VERMONT YANKEE CONTROLLED DOCUMENT TRANSMITTAL FORM

SECTION 1DOCUMENT TITLE: IMPLEMENTING PROCEDURES TO THE E-PLANCOPY NUMBER: 54CHANGE NUMBER: #196ISSUE DATE: November 26, 2001

Re: VY EPlan Implementing Procedure Change #196, Instruction Sheet

EMERGENCY COMMUNICATIONS

Figure 5
 OP 3504 Rev. 33
 Page 1 of 1
 LPC#1

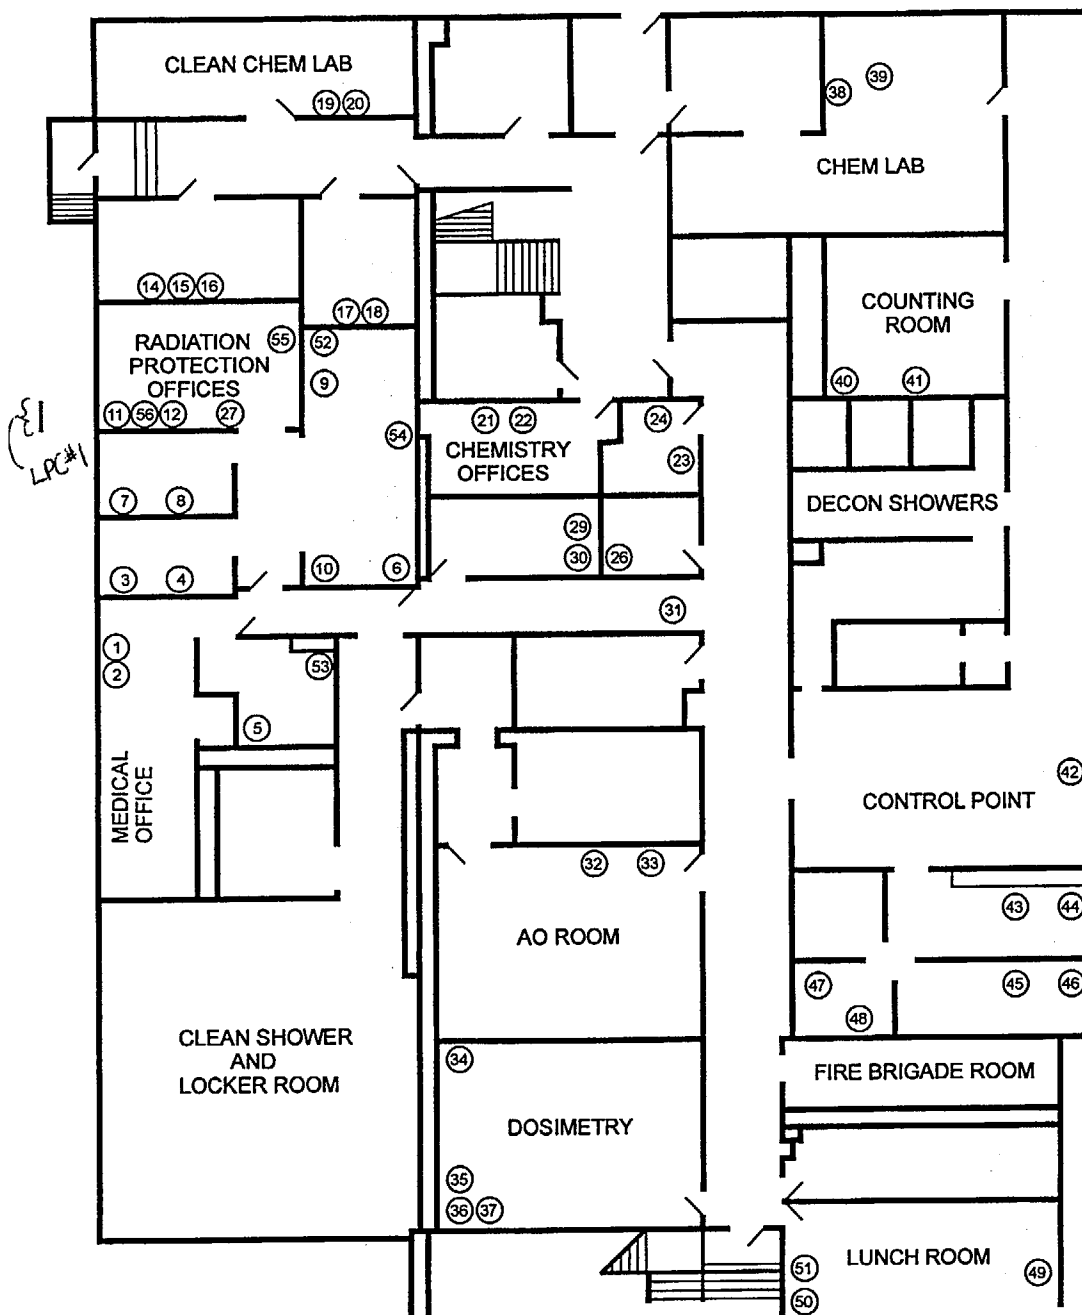
LPC No.	Effective Date	Affected Pages
1	11/15/01	Figure 5 Pg 1 of 1
